DEWEY PARK EMBRACE AND BELONGING CONCRETE FOUNDATION CONSTRUCTION REQUEST FOR PROPOSALS

Addendum 1

Appendix 1: Dewey Park draft site plan, includes add Alt pathway.

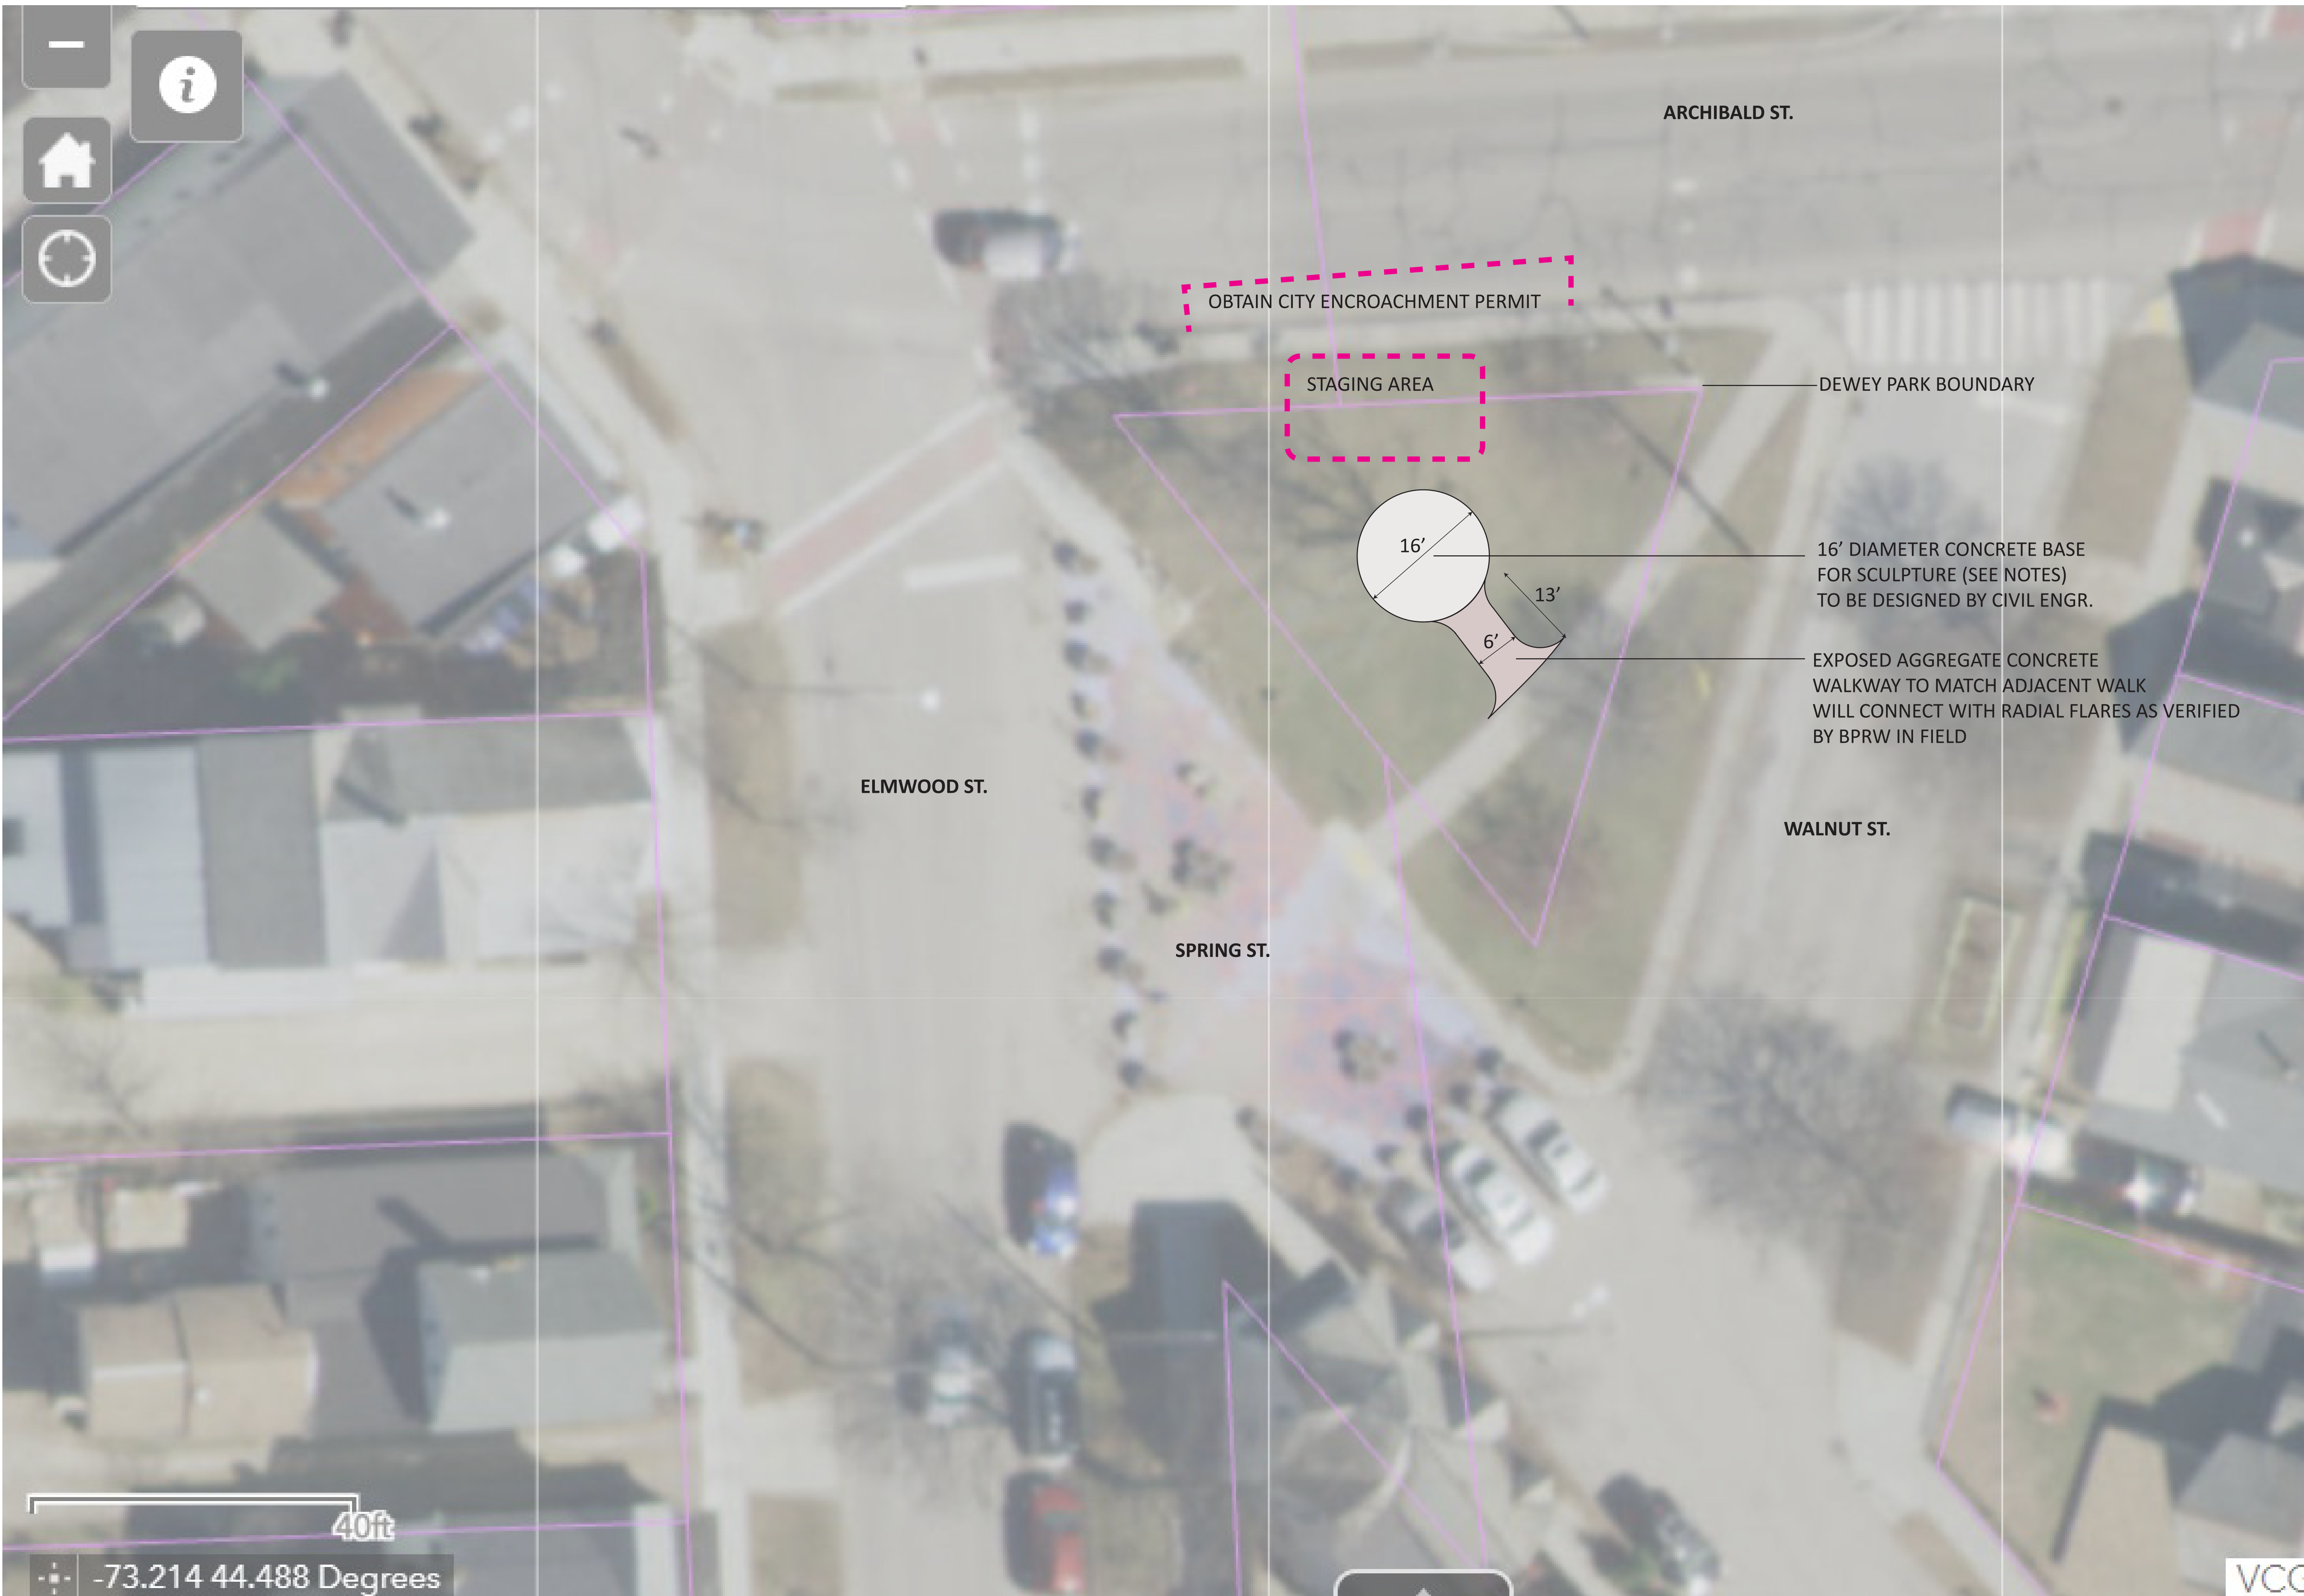
Ad Alternate: Pathway Connection

Please include an add alternative bid for the construction of an integrated, accessible pathway that matches the existing pathway in Dewey Park and connects the central pathway to the foundation. The pathway will be exposed aggregate concrete walkway to match adjacent walk and it will connect with radial flares as verified by BPRW in the field. See Appendix 1.
